FED. ROAD DIS. NO.	STATE	FED. AID PROJ. NO.	FISCAL YEAR	SHEET NO.	TOTAL SHEETS
HAWAII	HAW.	I-H3-1(59)	1993	ADD.31	211

STATE OF HAWAII DEPARTMENT OF TRANSPORTATION HIGHWAYS DIVISION	
GRADING NOTES EROSION AND SEDIMENT CONTROL MEASURES	
INTERSTATE ROUTE H-3 F.A.I. PROJECT NO. I-H3-1(59)	
SCALE: AS NOTED	DATE: JUNE 1993
SHEET No. D1 OF 32 SHEETS

ADD. 31

9/30/93	REVISION
DATE	REVISION
STATE OF HAWAII DEPARTMENT OF TRANSPORTATION HIGHWAYS DIVISION	
GRADING AND DRAINAGE PLAN	
STA. 386+00 TO STA. 397+00	
INTERSTATE ROUTE H-3 F.A.I. PROJECT NO. I-H3-1(59)	
SCALE: 1" = 40'	DATE: JUN 1993
SHEET NO. 03 OF 32 SHEETS

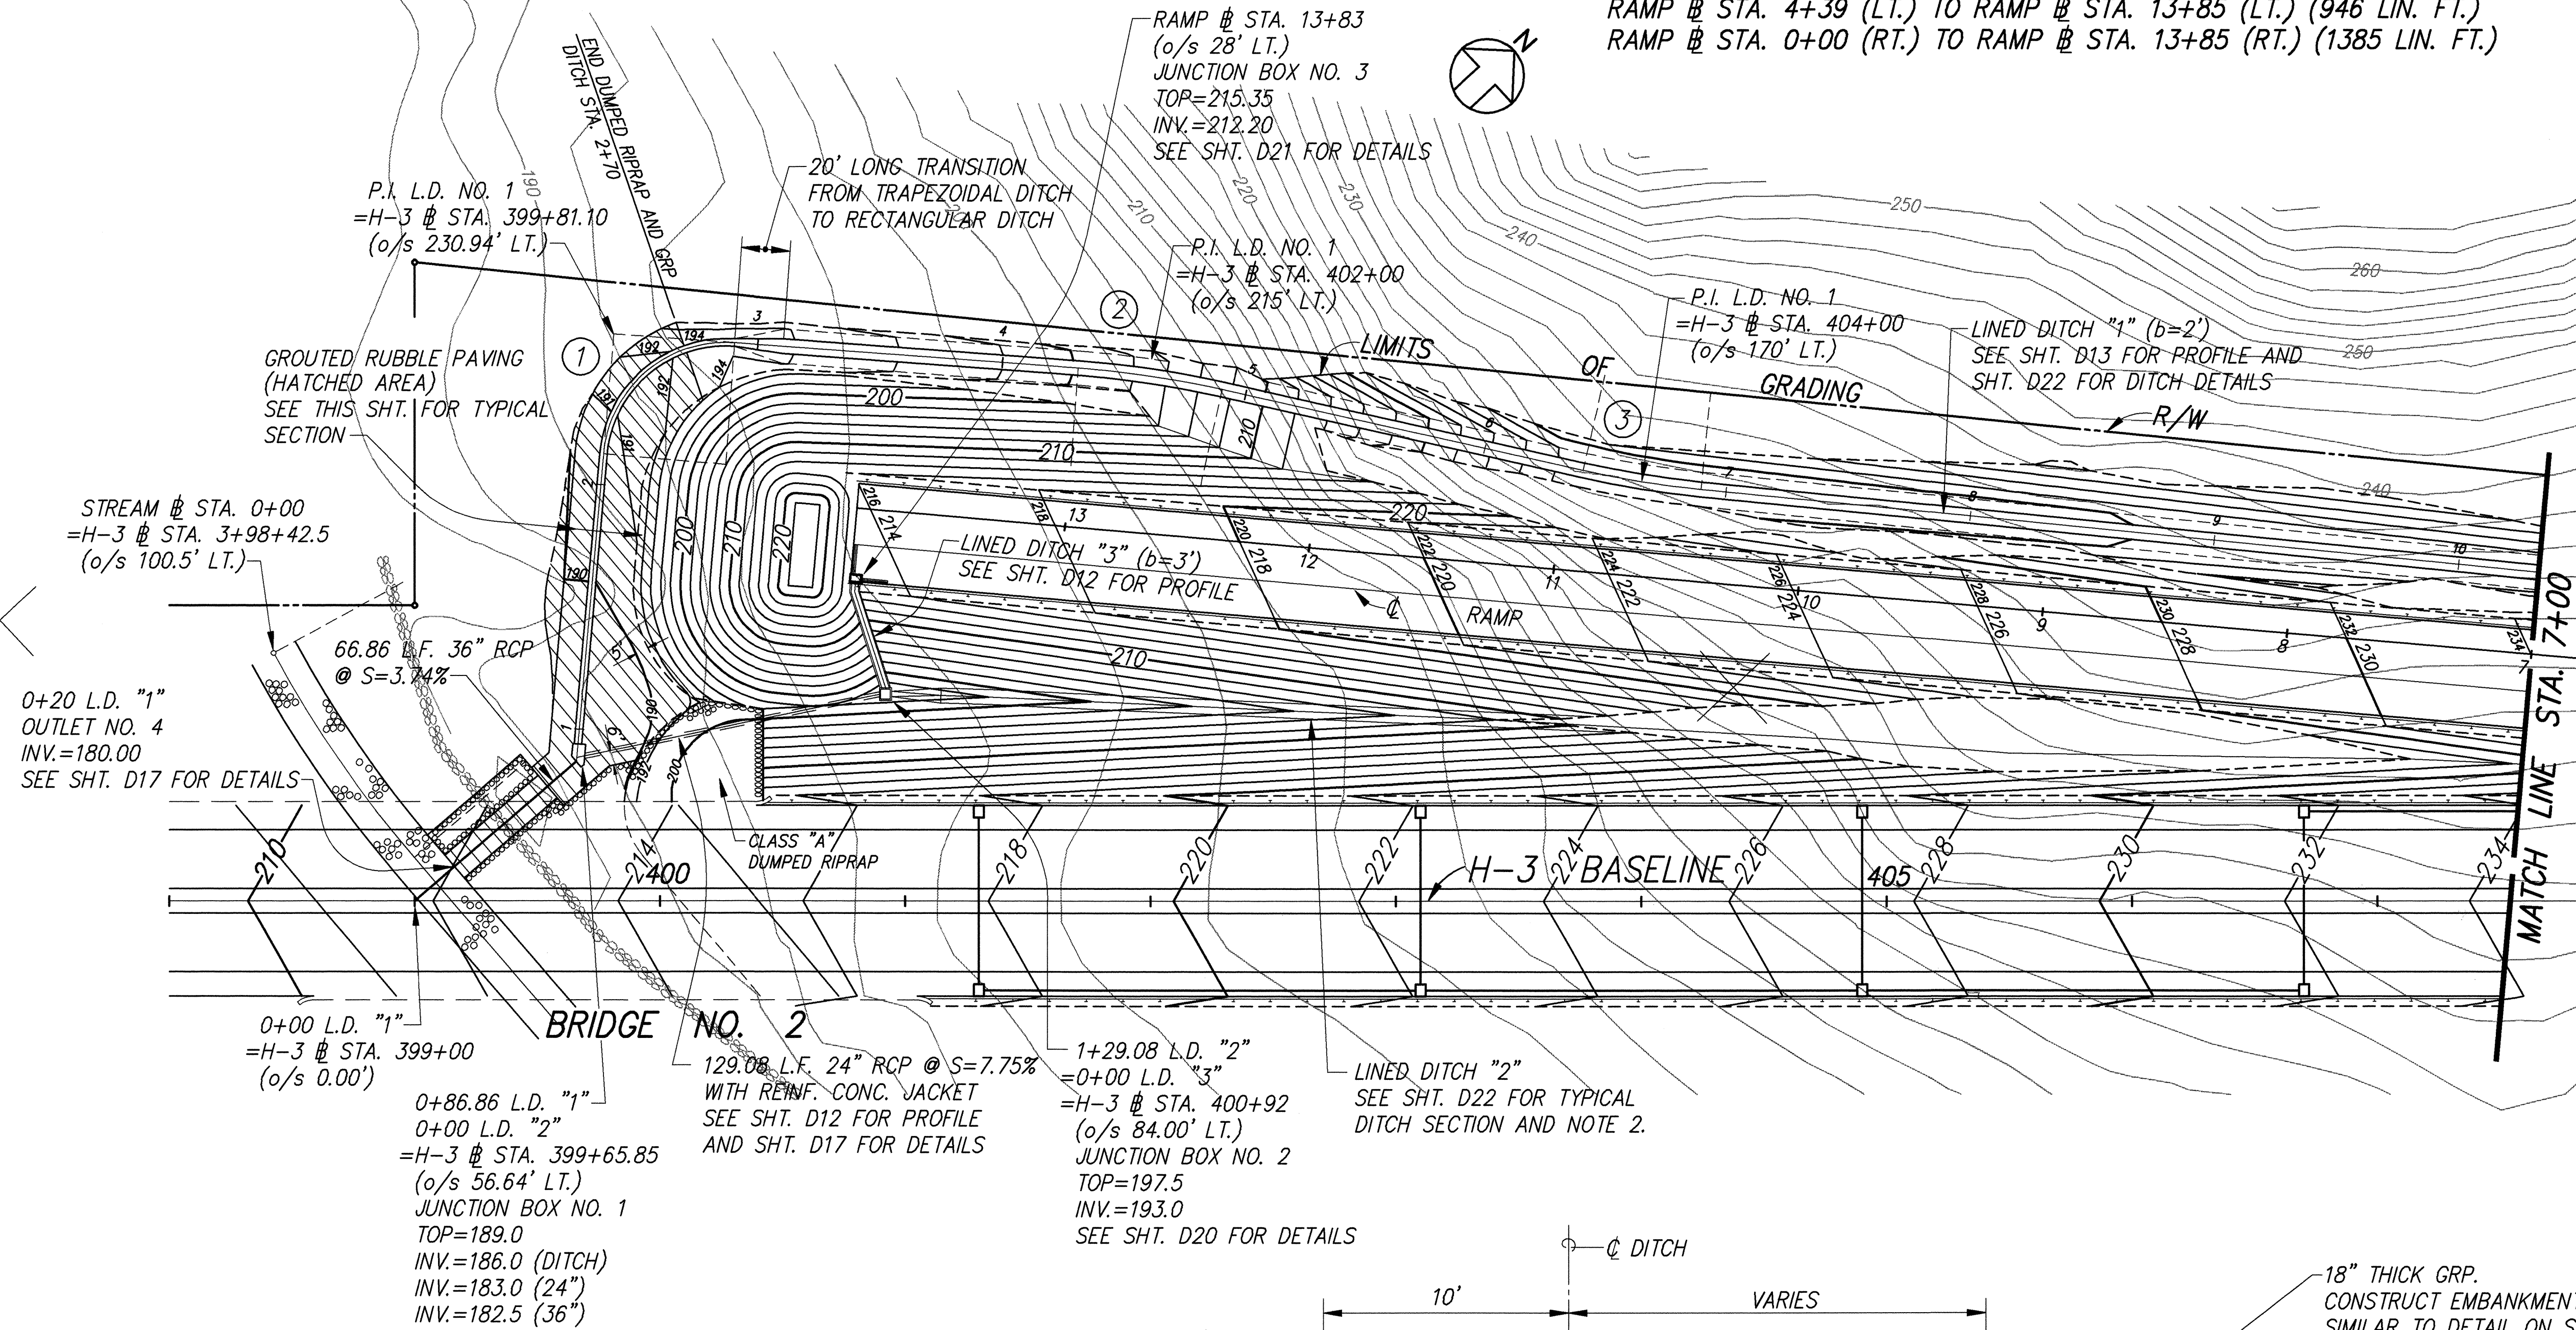
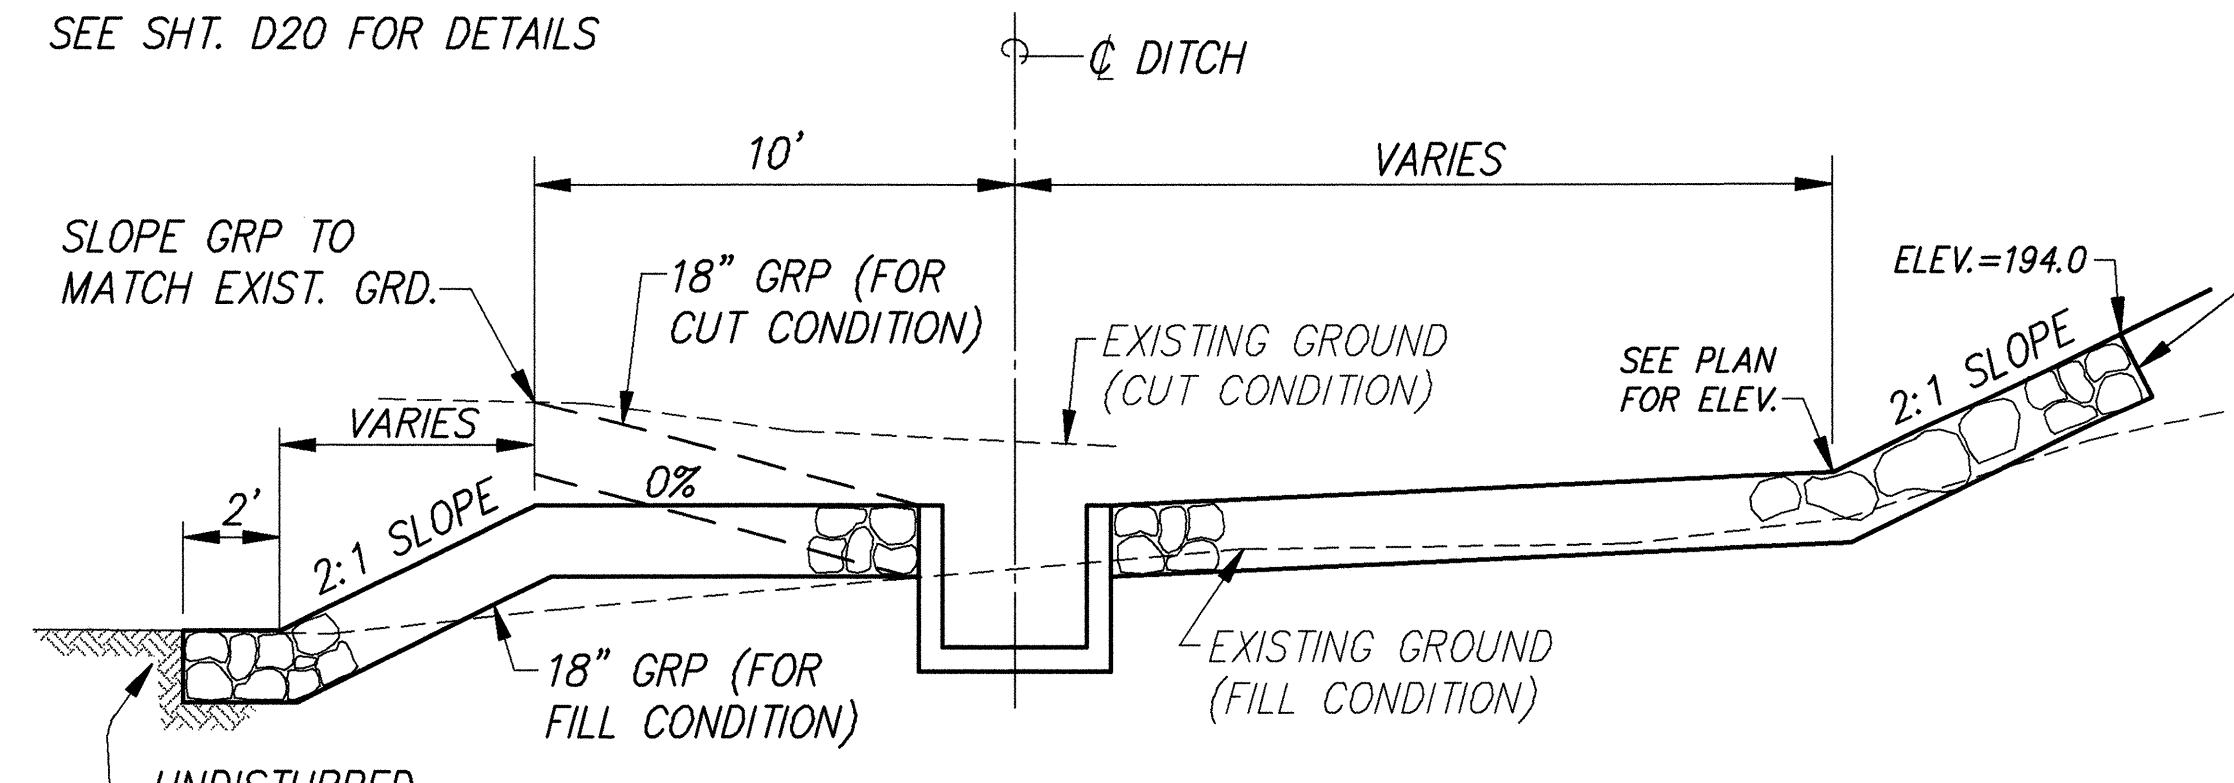
DATE	9/30/93	REVISION	REVISED DRAIN LINES "R" "S" "V" AND "W". ADDED CLEANOUTS FOR UNDERDRAINS. ADDED GRP AT MBERIN NO. 3
STATE OF HAWAII DEPARTMENT OF TRANSPORTATION HIGHWAYS DIVISION GRADING AND DRAINAGE PLAN STA. 408+00 TO STA. 415+00 INTERSTATE ROUTE H-3 F.A.I. PROJECT NO. I-H3-1(59) SCALE: 1" = 40' DATE: JUN 1993 SHEET No. 05 OF 32 SHEETS

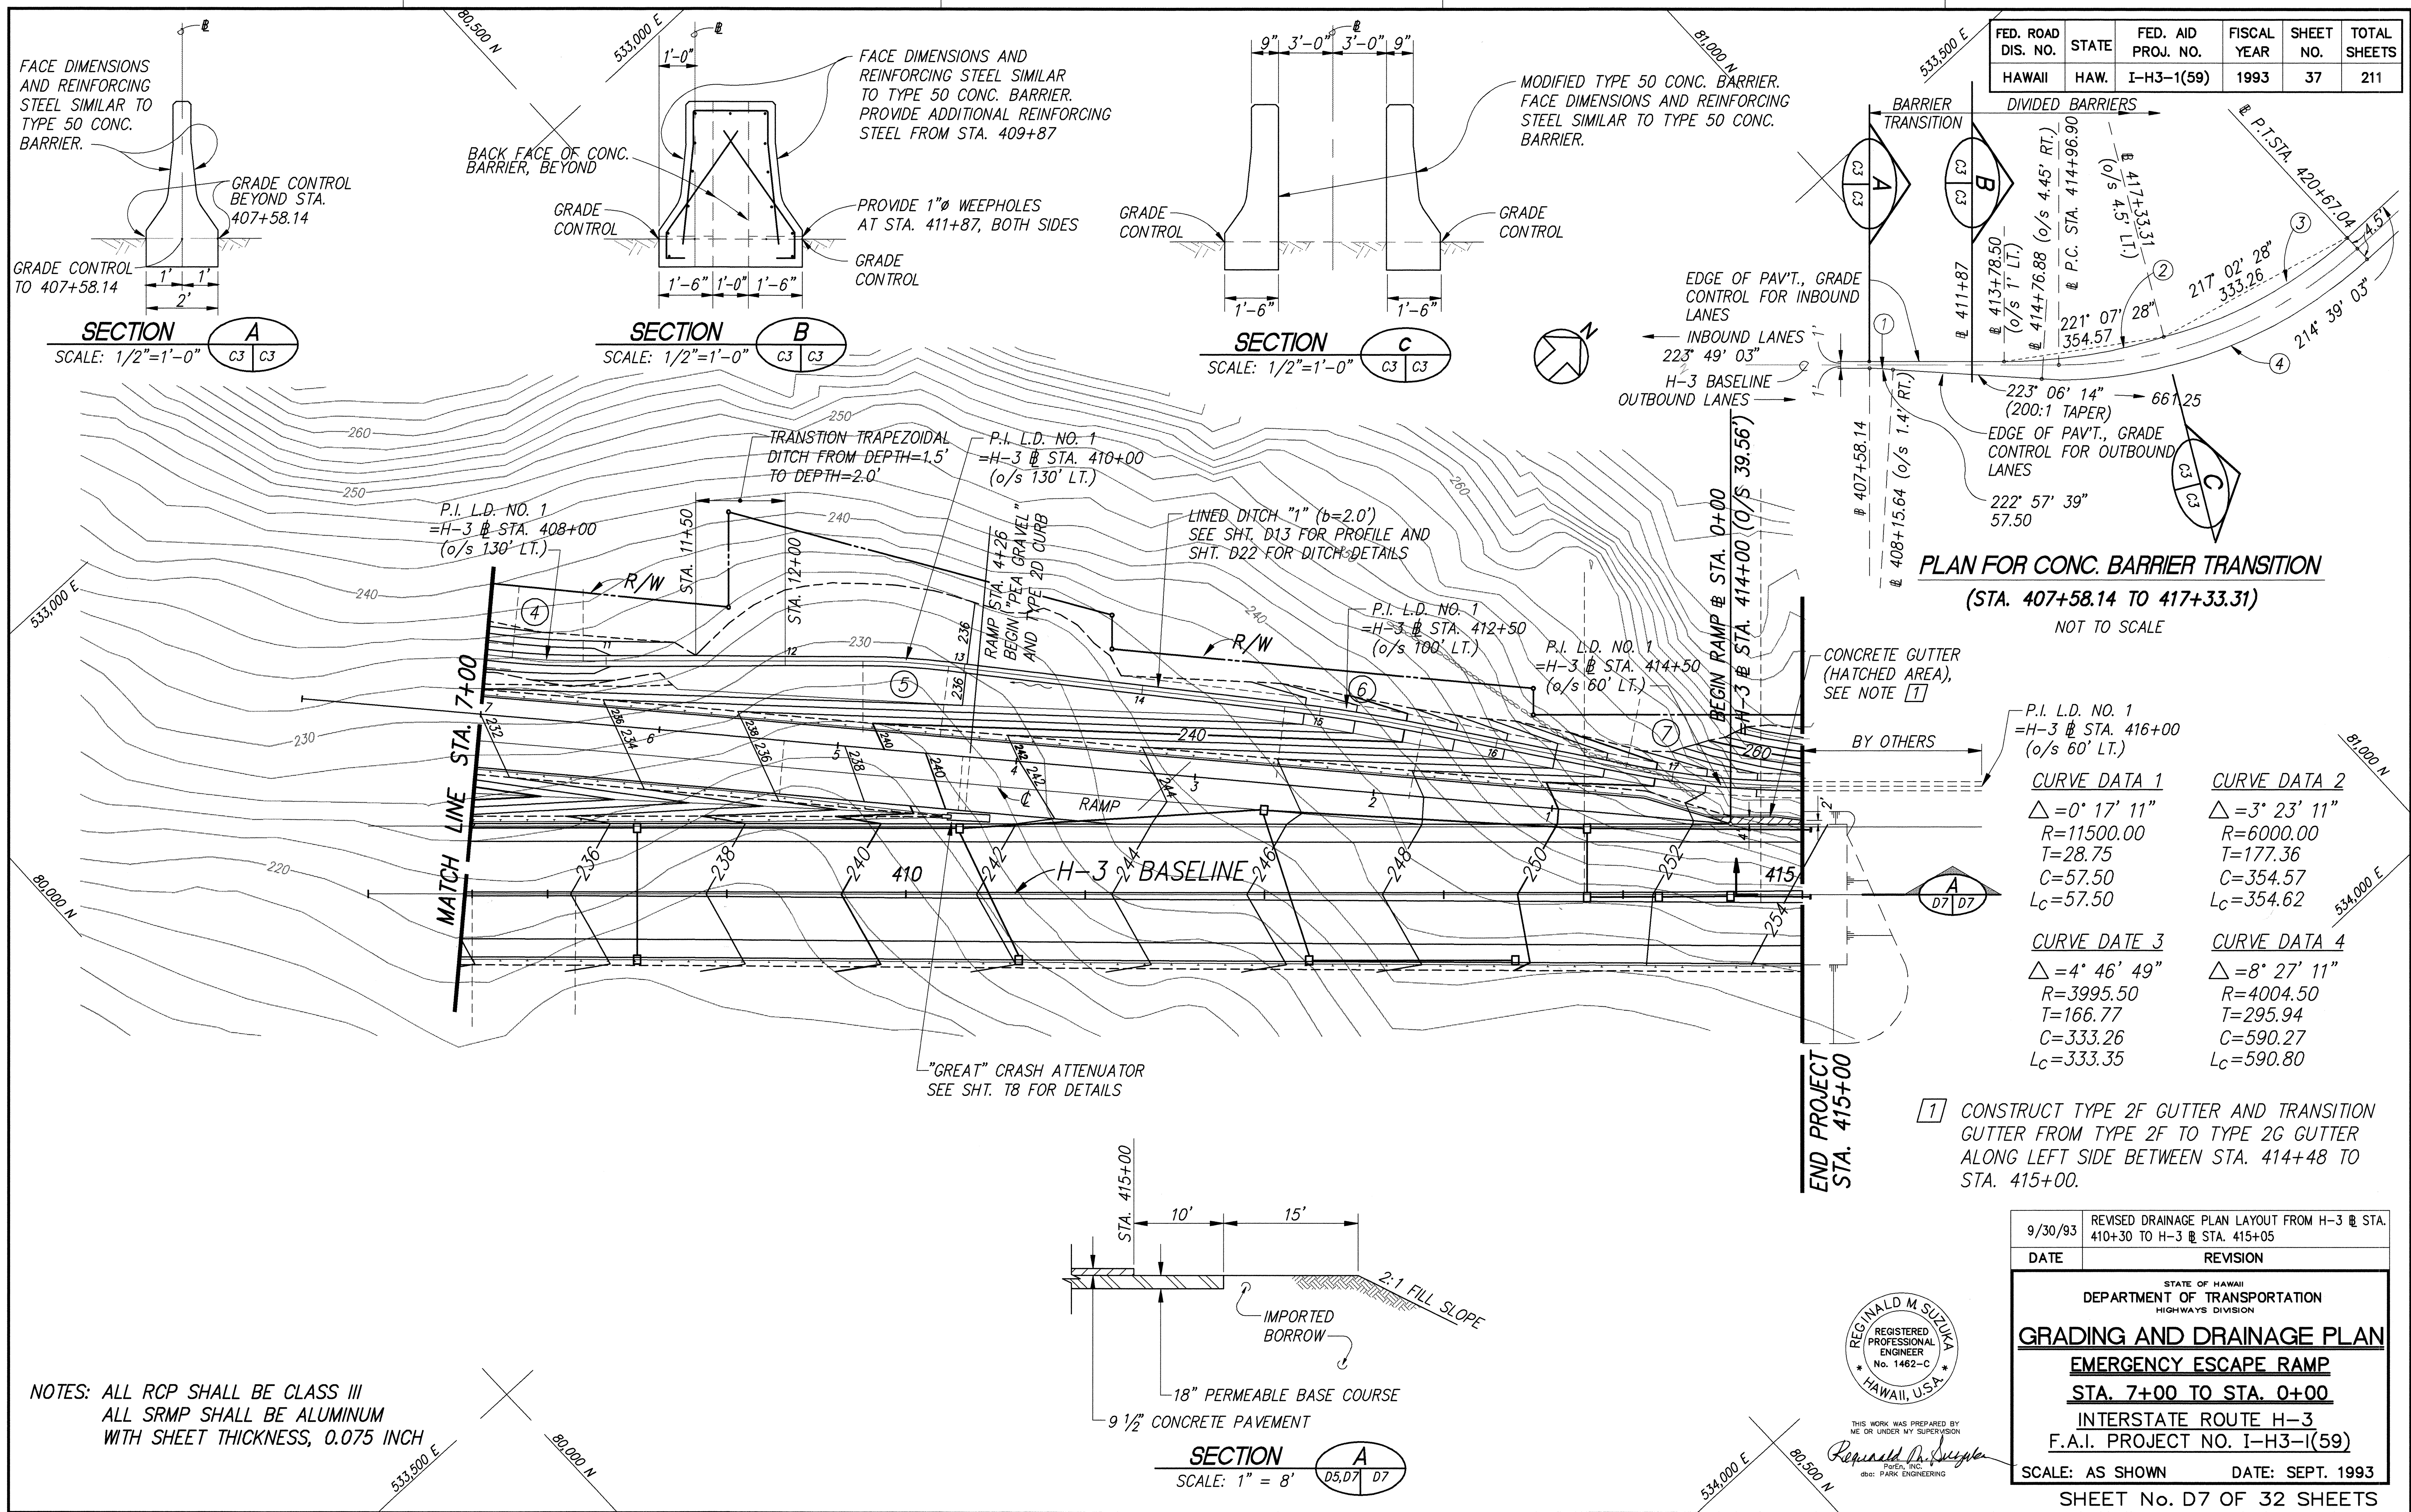
9/30/93	REVISED DRAINAGE PLAN LAYOUT FROM H-3 @ STA. 410+30 TO H-3 @ STA. 415+05
DATE	REVISION
STATE OF HAWAII DEPARTMENT OF TRANSPORTATION HIGHWAYS DIVISION	
GRADING AND DRAINAGE PLAN	
EMERGENCY ESCAPE RAMP	
STA. 7+00 TO STA. 0+00	
INTERSTATE ROUTE H-3	
F.A.I. PROJECT NO. I-H3-I(59)	
SCALE: AS SHOWN	DATE: SEPT. 1993
SHEET No. D7 OF 32 SHEETS

PROFILE - DRAIN LINE 'R'
EMERG. RAMP @ STA. 2+60 TO
H-3 STA. 412+25

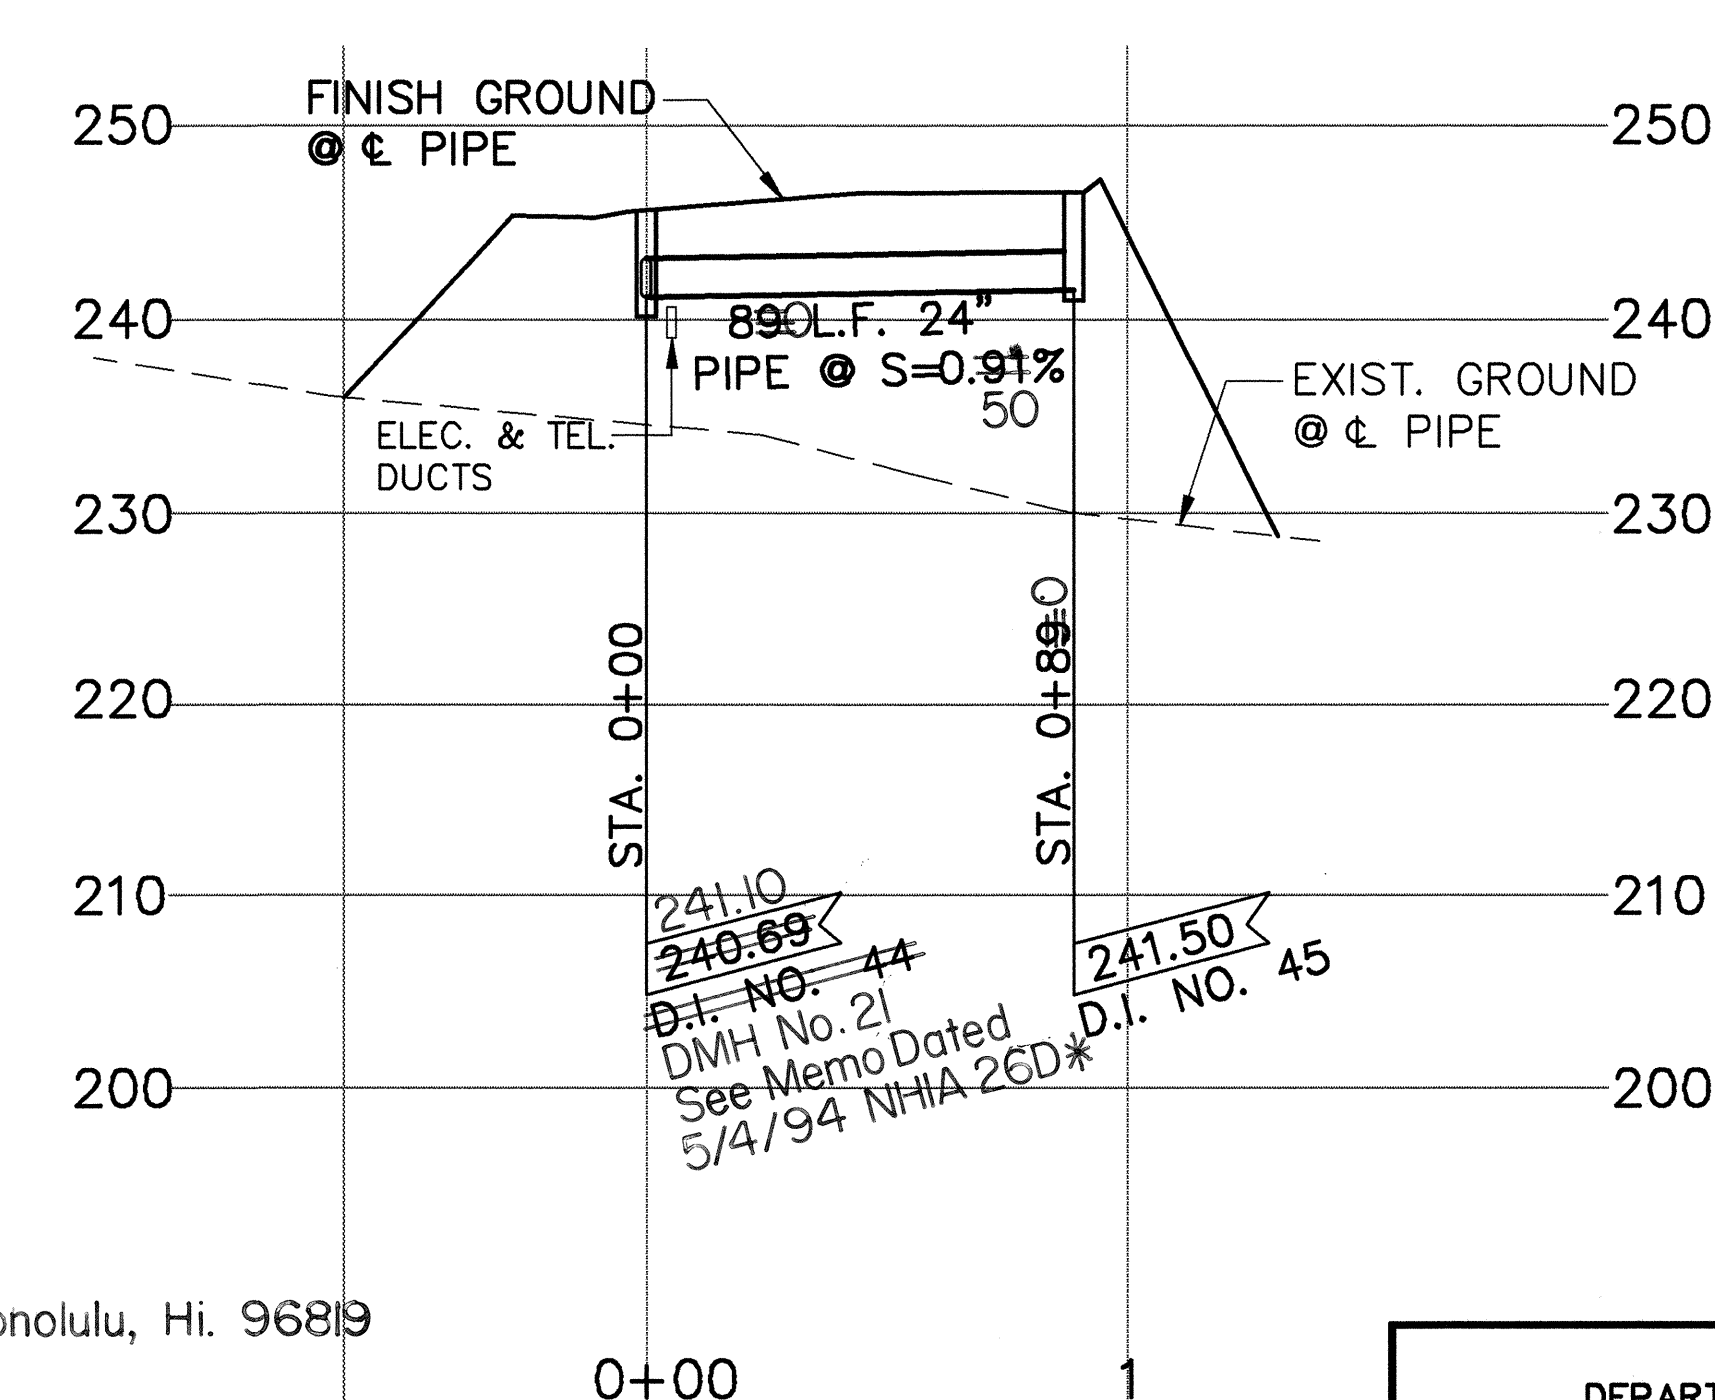
9/30/93	REVISED PROFILE OF DRAIN LINE "R"
DATE	REVISION
